Subject: YAESU MUSEN CO. LTD. FCCID: K66VX-800V

REFERENCE: EA 95595

After the training session last week I decided to review all of our pending applications based on what was learned last week. Attached you will find several pages with corrected data. The corrections are;

GENERAL INFORMATION REQUIRED
FOR TYPE ACCEPTANCE

2.989(c) Occupied bandwidth:

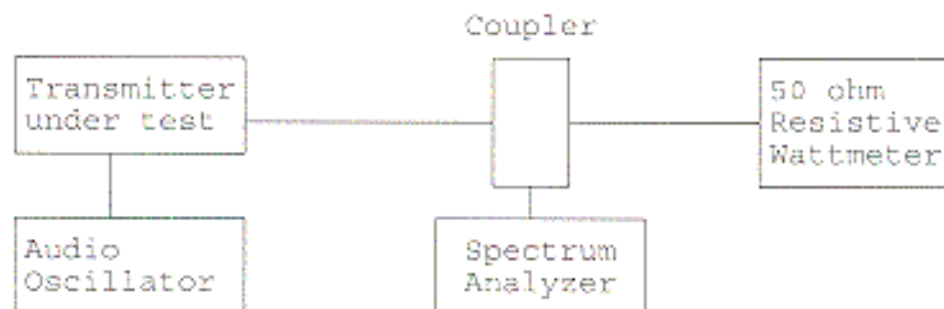
1. The power output is average conducted power.
2. Occupied bandwidth, I found several errors on that page.
3. The radiated emission were retested using the TIA/EIA-603 test procedure.
4. The audio frequency response was extended to cover the 100-5000Hz requirement.
5. Occupied bandwidth plots, the mask was added.

Data in the plots shows that on any frequency removed from the assigned frequency by more than 50%, but not more than 100%: At least 25dB. On any frequency removed from the assigned frequency by more than 100%, but not more than 250%: At least 35dB. On any frequency removed from the assigned frequency by more than 250%, of the authorized bandwidth: At least $43 + \log(P)$ dB.
